E88-07/08

1013.3, 1025.14.1 (IFC [B] 1013.3, 1025.14.1)

Figure 1

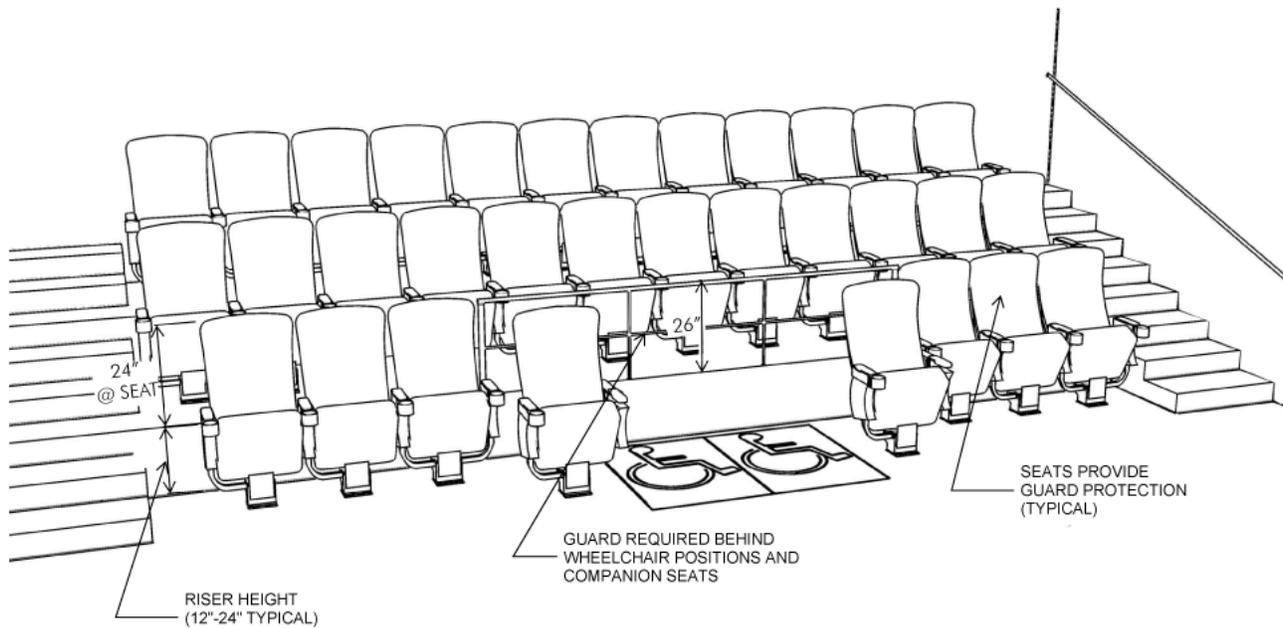
4. In assembly seating areas where an elevation change of ~~less than~~ 30 inches or less occurs between successive aisle accessways serving seating, or between an aisle accessway serving seating and a cross aisle and the adjacent floor or grade below, or between successive tiers of seating, guards complying with Section 1025.14 shall have balusters or ornamental patterns such that a sphere with a diameter of 21 inches (533 mm) can not pass through any opening.

Commenter's Reason: At the public hearings in Palm Springs, CA there was a misunderstanding by some members of the Means of Egress Committee as to the conditions which this code change attempts to address. In most movie theaters with stepped ("stadium") seating, and in many other similar fixed seat assembly spaces, wheelchair positions are placed where seats would normally be placed. In addition the required companion seats are typically set further forward to be "shoulder to shoulder" with the person in the wheelchair. Both the wheelchair space and the forward set companion seat eliminate the guard protection typically provided by the seat back and required for the aisle accessway on the level behind (the exception to Section 1025.14.1 allows the seat backs, if they project 24 inches or more above the adjacent floor behind to fulfill the guard requirement). See Figure 1 below. The larger openings in the guard proposed by this code change provide equal guard protection to the seat backs they replace which often have space between them larger than 4 inches. Further as was noted in the supporting statement of the original proposal, guards are typically not required elsewhere in a building when the change in elevation between a walking surface and the floor or grade below is equal to or less than 30 inches. The most typical changes in elevation in stepped seating conditions in assembly spaces is between 12 and 24 inches. The specific modifications to the original proposal that are now being suggested are two-fold. The first is a simple change to coordinate better with the Section 1013 which requires guards when the level change is greater than 30 inches. The second modification references the term "aisle accessway serving seating" instead of tiered seating. Section 1025.10 specifically uses the term "aisle accessway serving seating" to describe the walking surface between successive rows of fixed seating. At the public hearings in Palm Springs there was testimony in opposition to the code change proposal stating that the term "tiered seating" was too broad. This second modification addresses that concern.
